The range of MMX ovens without pyrolytic function includes different clocks depending on each of the versions for the different models.

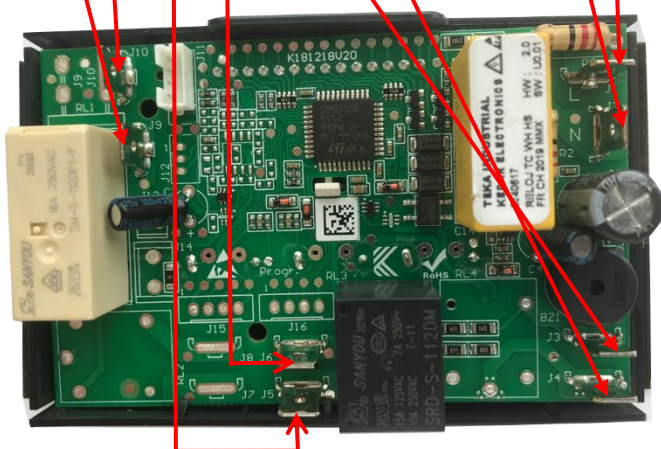
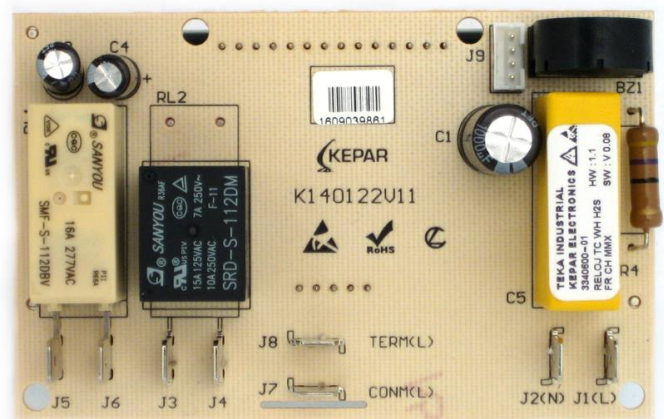
83340600 / 83340620 clocks connectors are located in the same area, and they are 100% compatible at HW and SW level (the only difference is the component supplier).

The three clock references we have (83340600 / 83340620 / 83340617) are fully interchangeable in both senses (see attached compatibility diagram).

Connectors 83340600 / 83340620	Connectors 83340617
J1	J1
J2	J2
J3	J5
J4	J6
J5	J9
J6	J10
J7	J3
J8	J4
